Seismic Walkdown Checklist (SWC)

Equipment ID No. Q1R43E001A Equip. Class[1] 20

Equipment Description SEQUENCER B1F

Location: Bldg. AUXILIARY Floor El. 139 Room, Area 335

UNIT 1
FL-98
FL-98

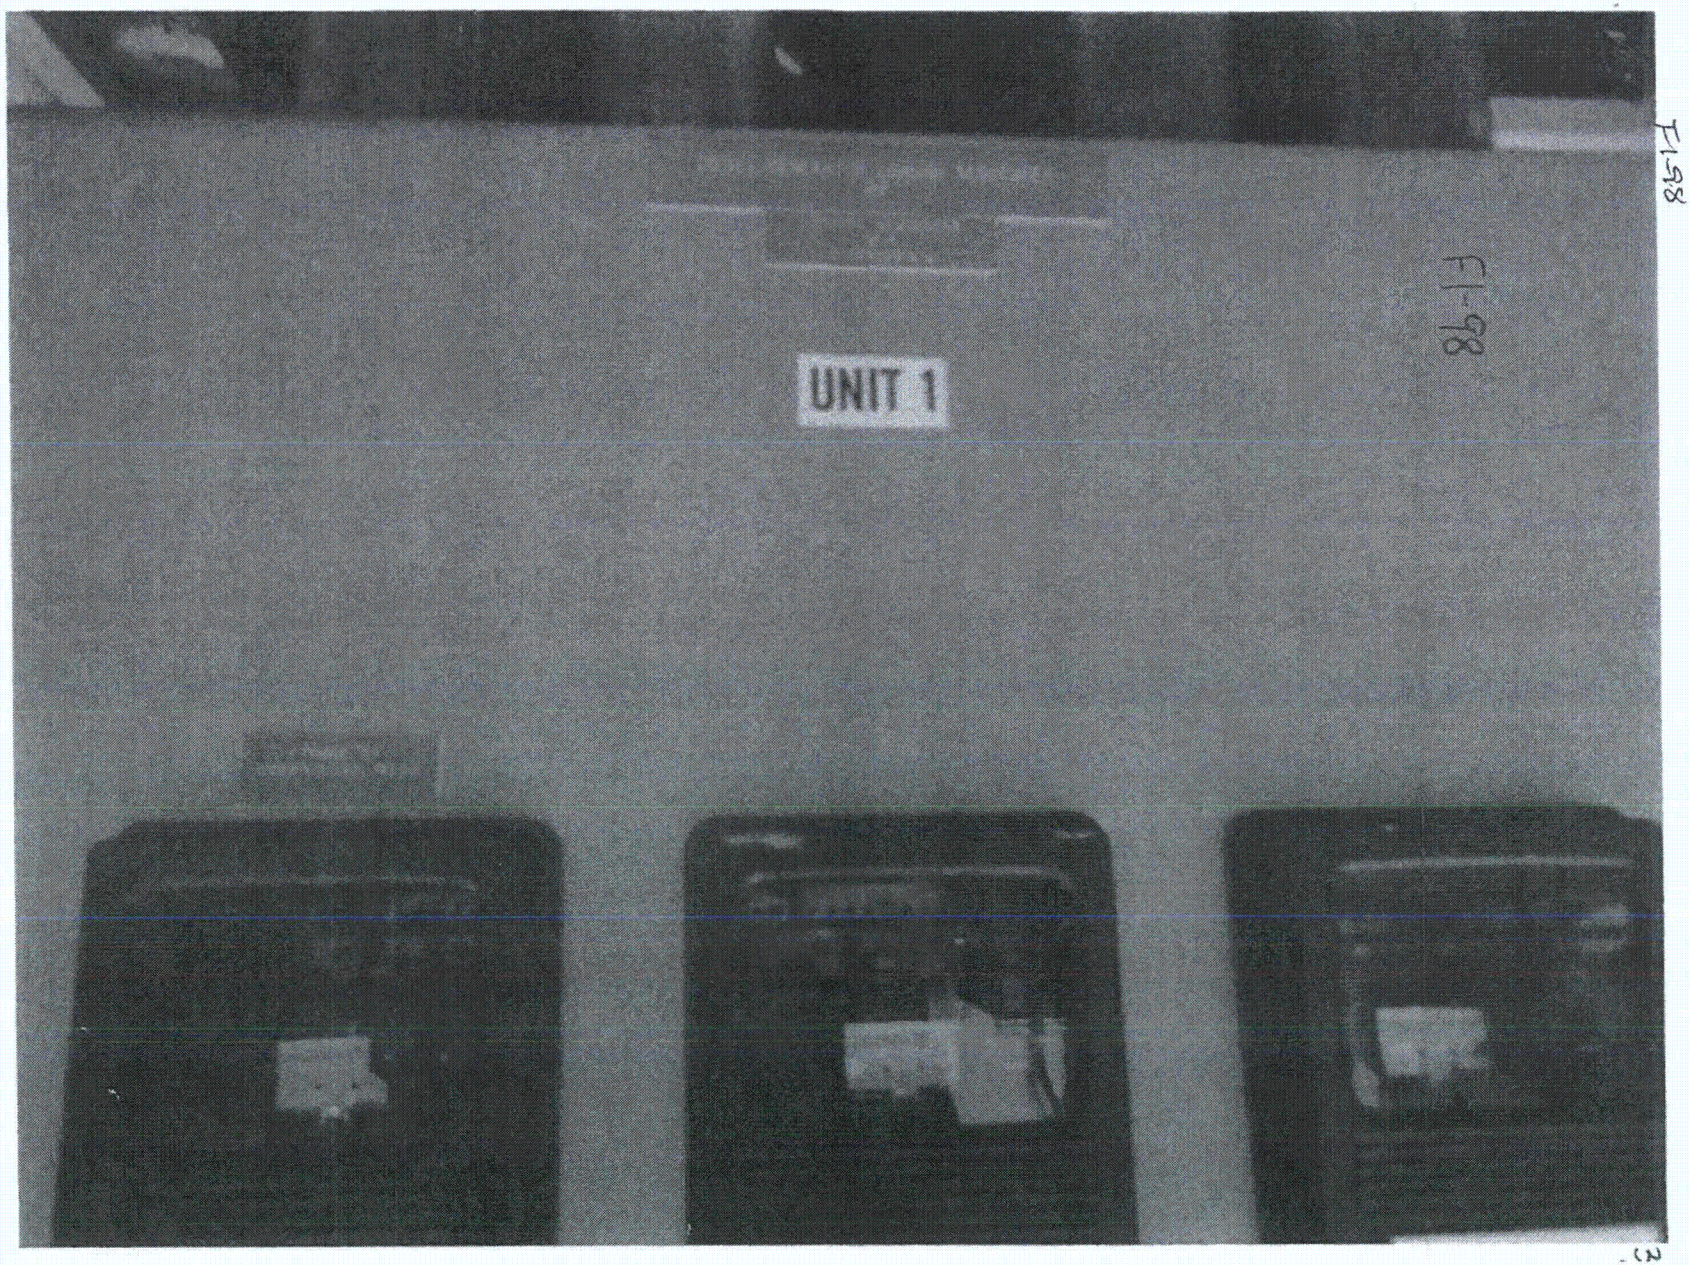
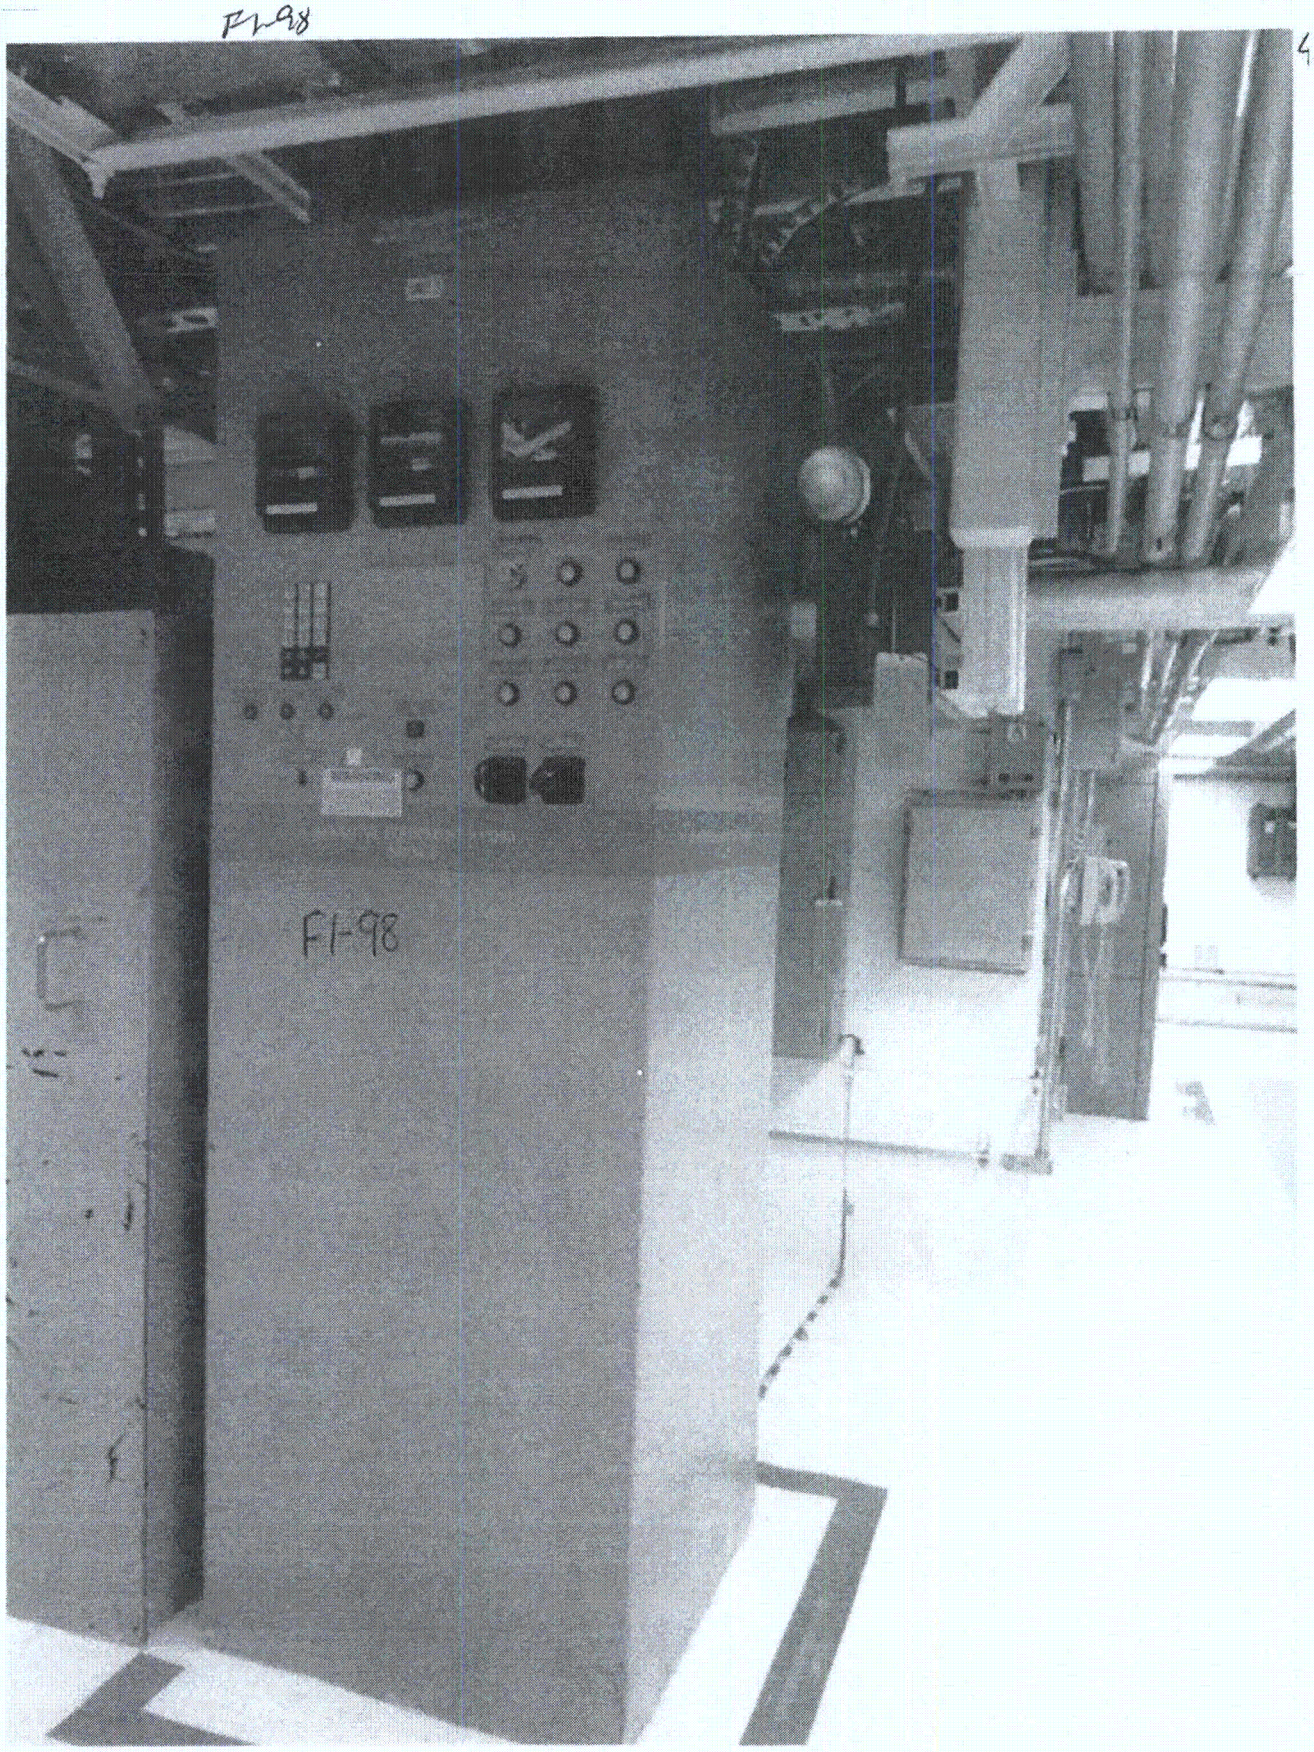
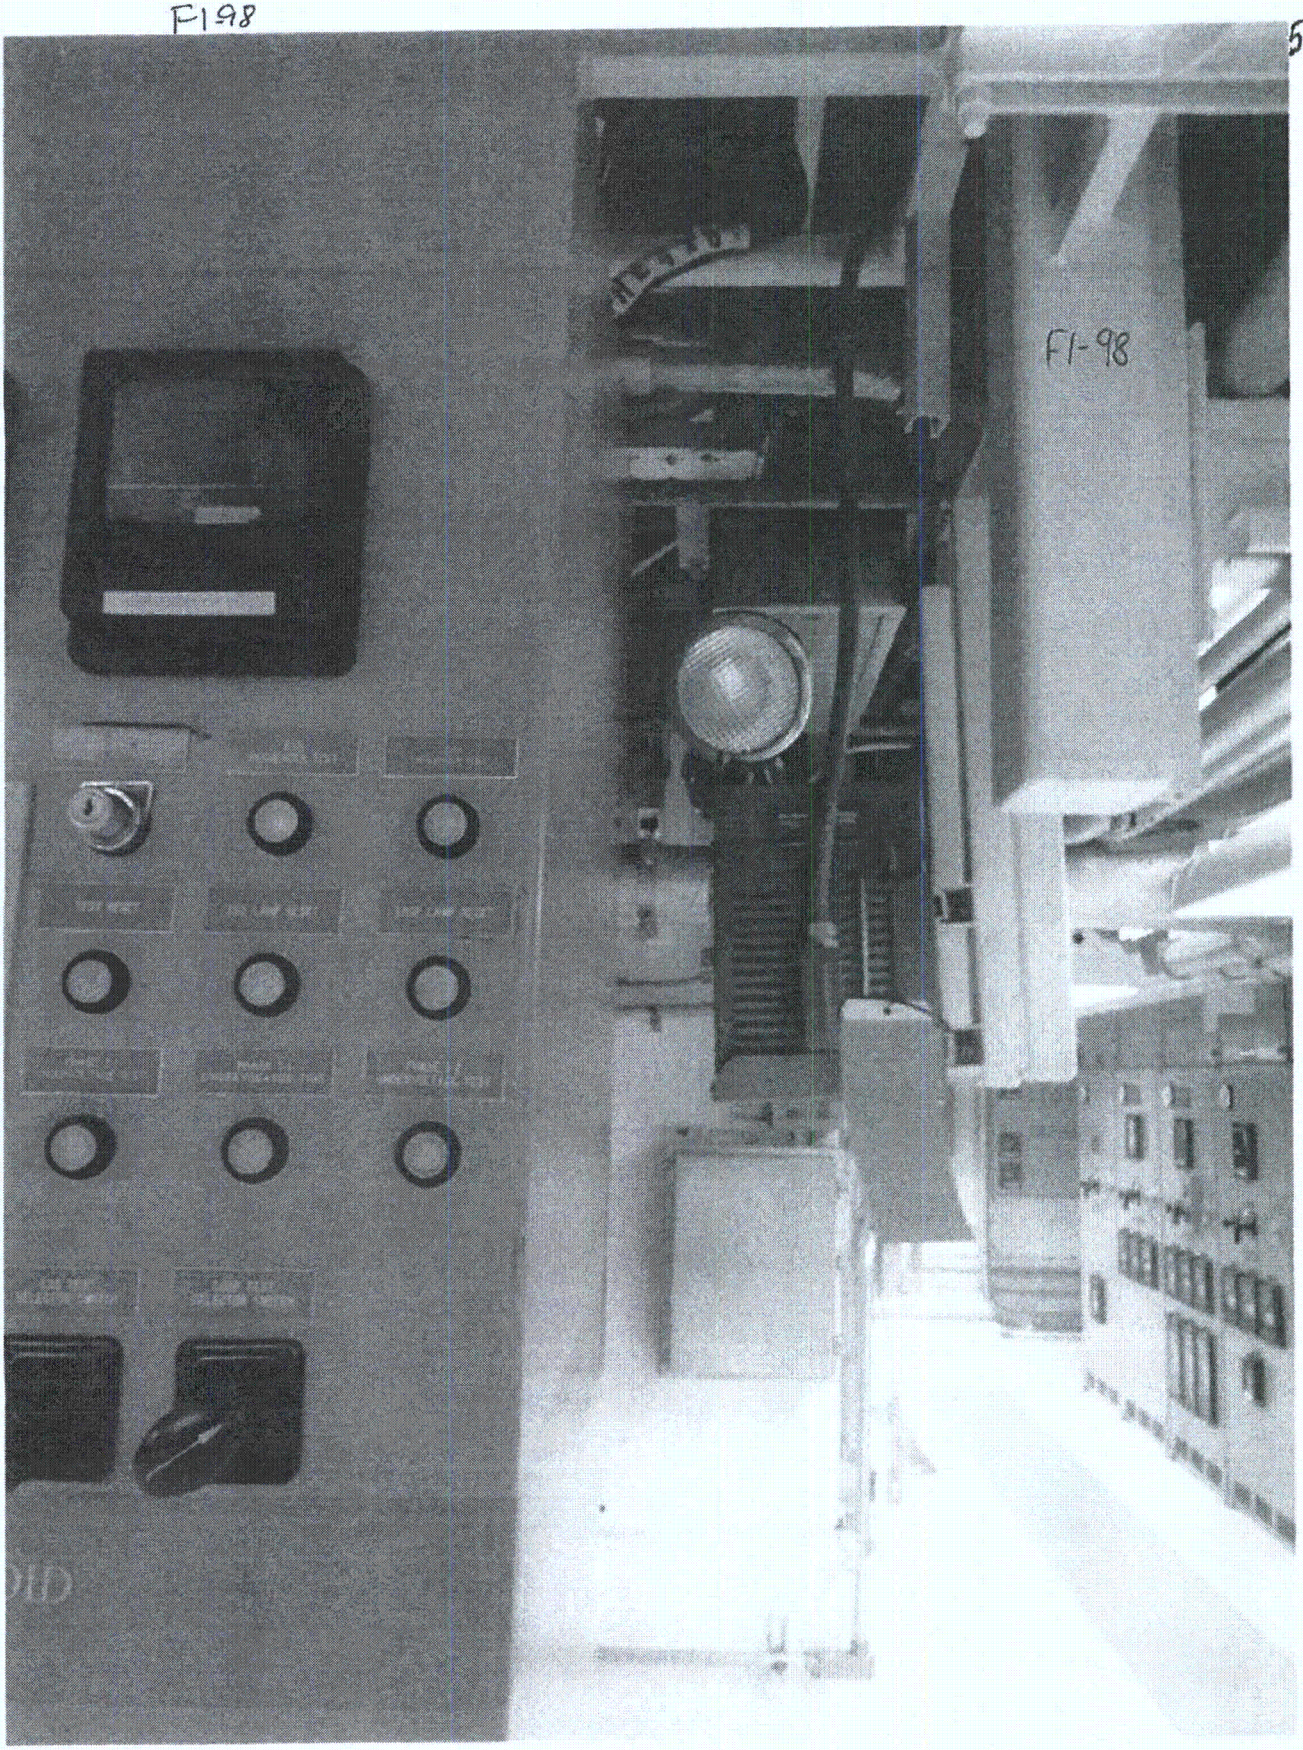
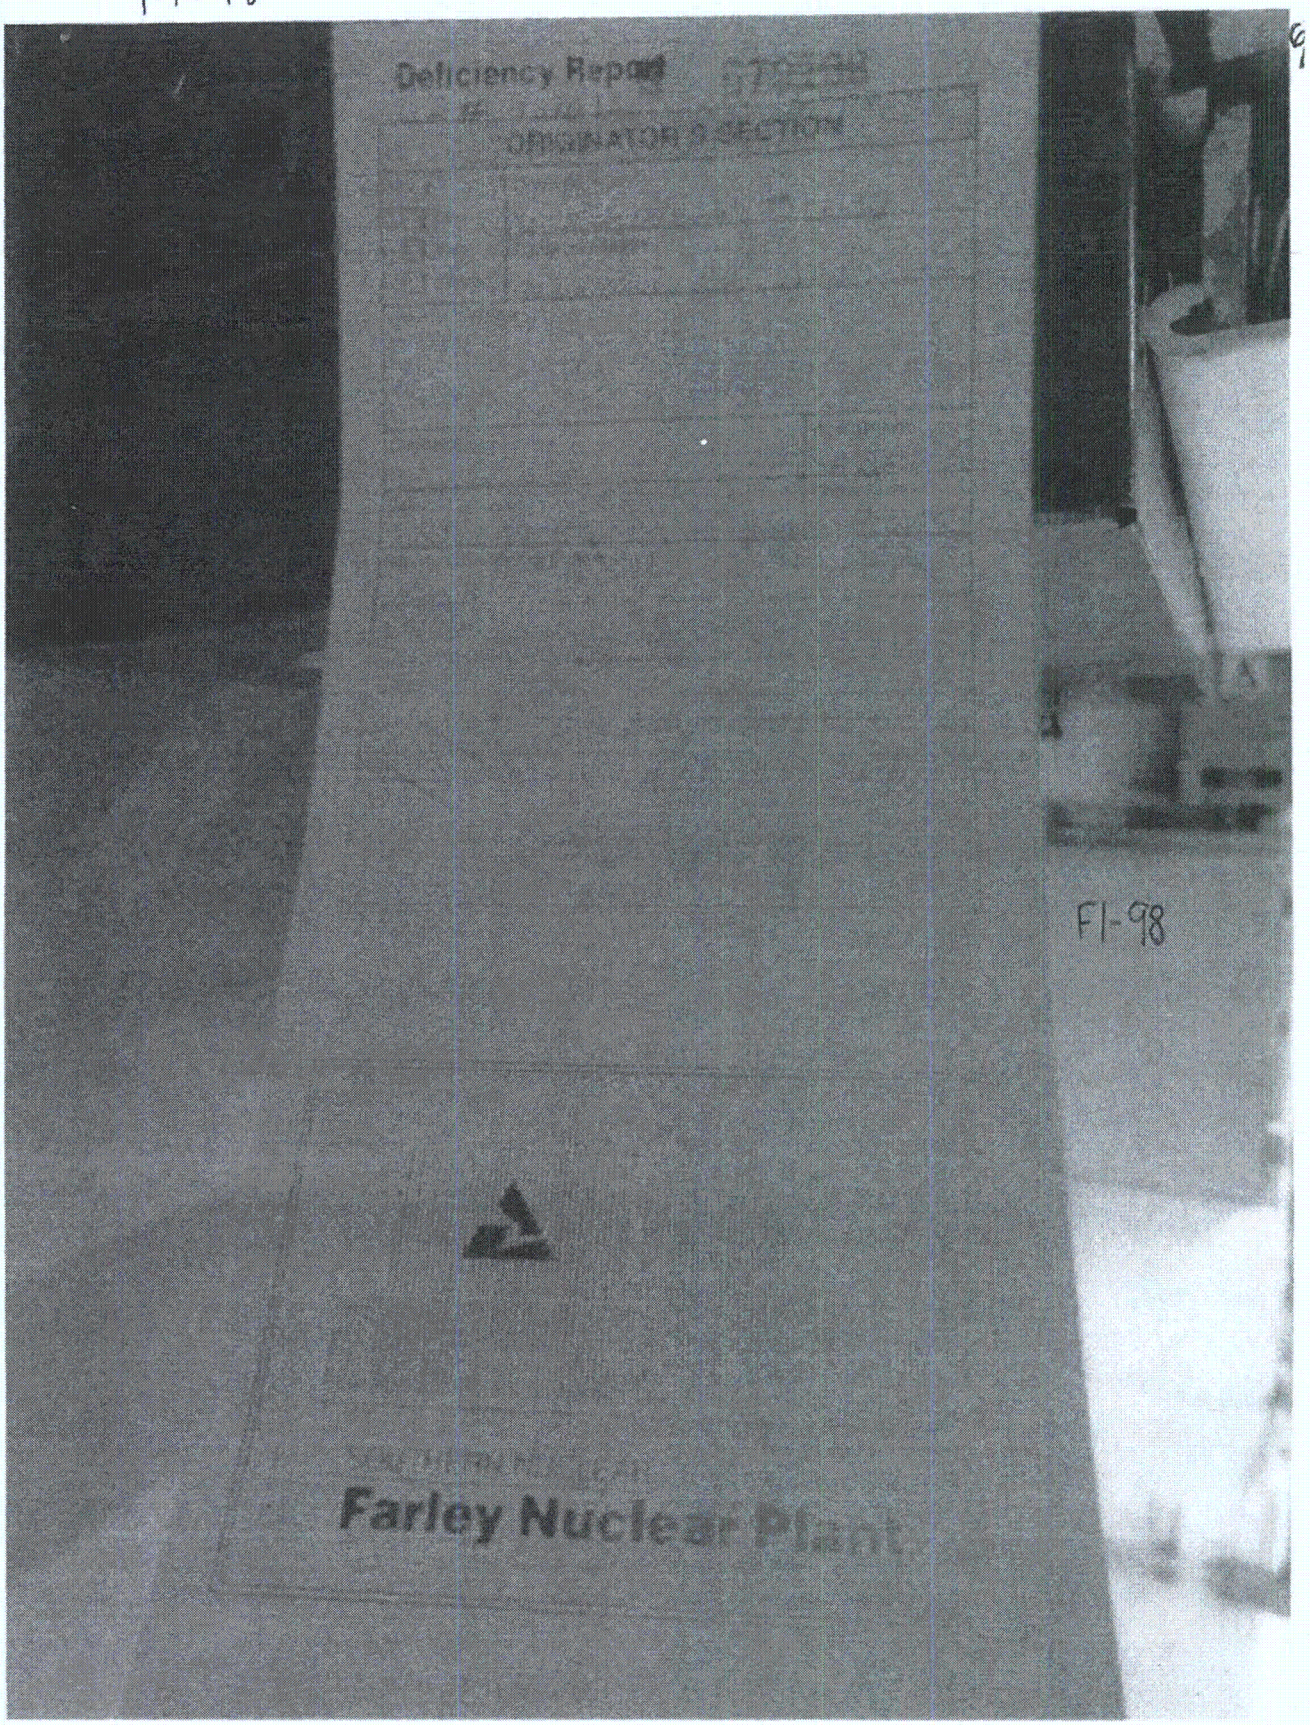
UNE 8/26 ~~Refer to Area Walkdown~~ As documented in CR# 497075 Emergency Light #1115 (N5R45EL001) is within 3" and could bump DG Load Sequencer B1F (Q1R43E001A) during normal maintenance or a seismic event. This CR was written prior to the walkdown.

QIR43E002A-A
SEQ BUS IF
AUX PNL
UNIT 1
PHASE 3-1
DEGRADED GRID TEST
PHASE 2-3
DEGRADED GRID TEST
PHASE 1-2
DEGRADED GRID TEST
PHASE 2-3
PHASE 1-2

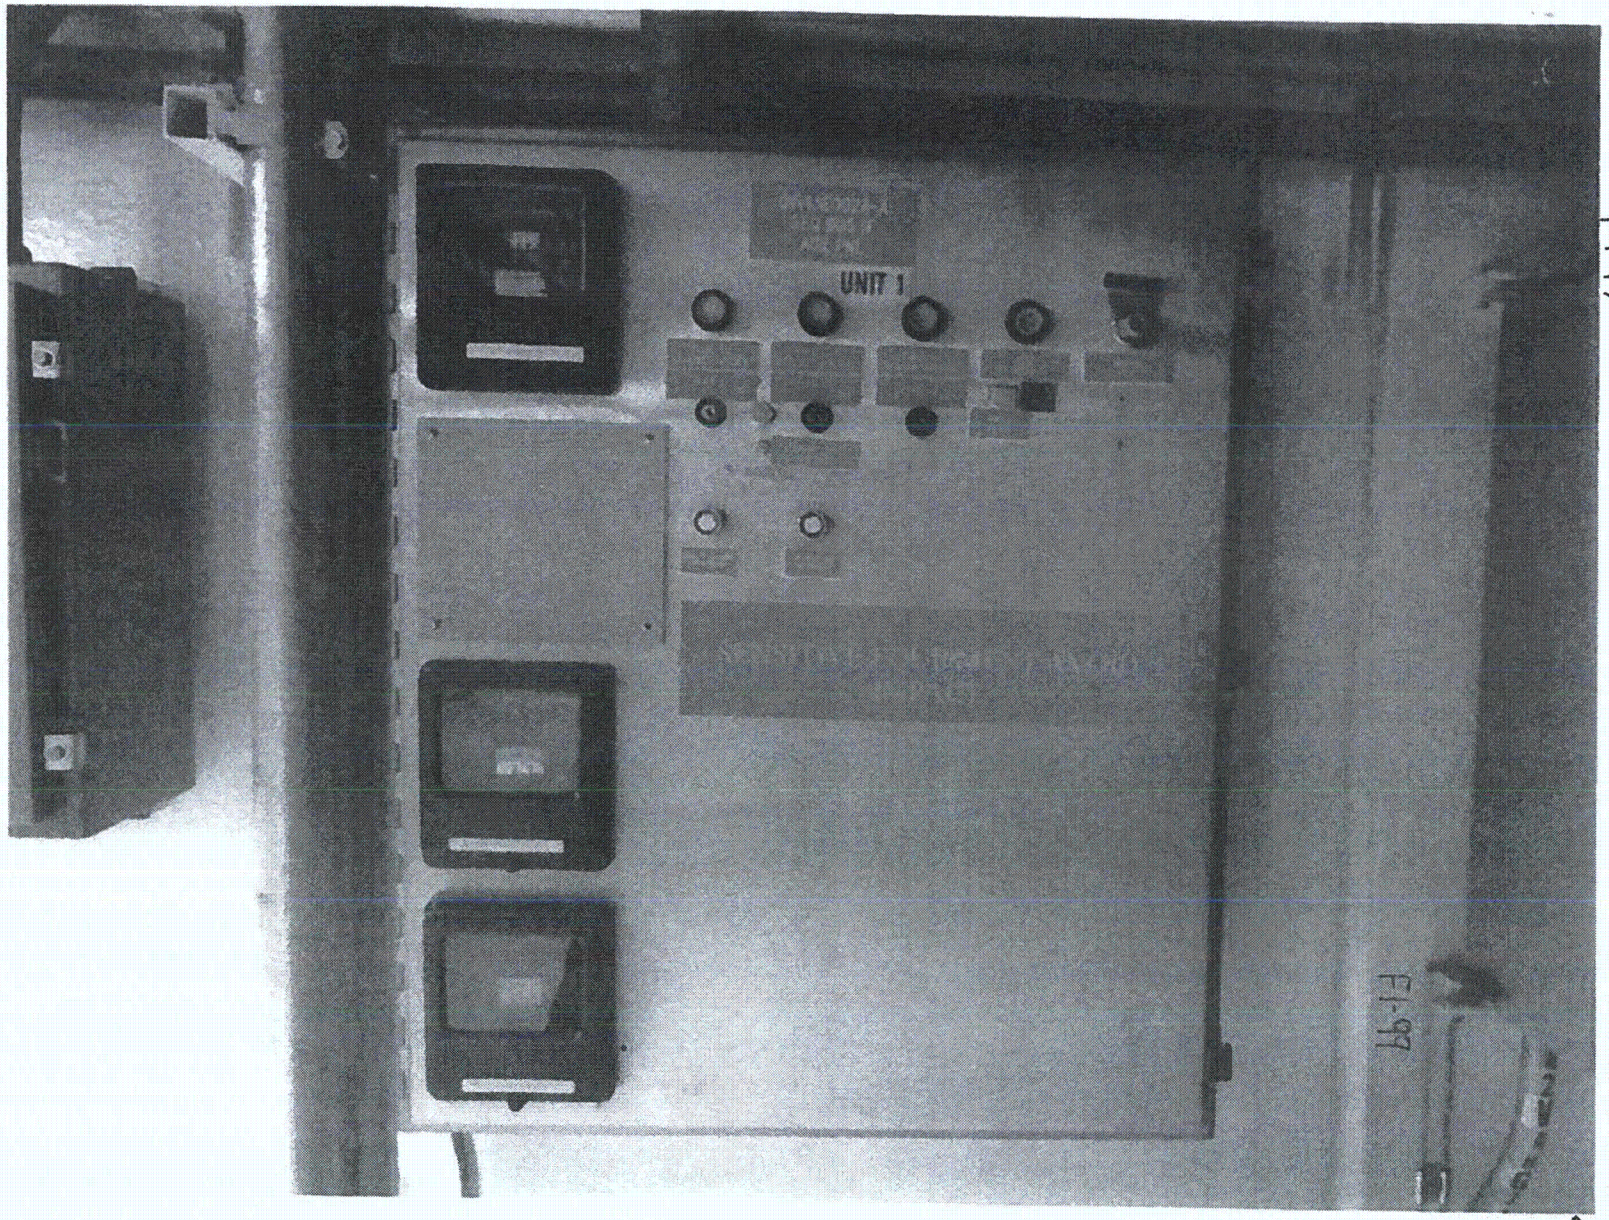
7. Are soft targets free from impact by nearby equipment or structures? Y☒ N☐ U☐ N/A☐
   Three two inch conduits are supported on the East side of the cabinet. The gap between the conduits and panel is about 1", but due to the rigid conduit support (welded to an embedded wall plate), the cabinet is judged to be free from impact during a seismic event.
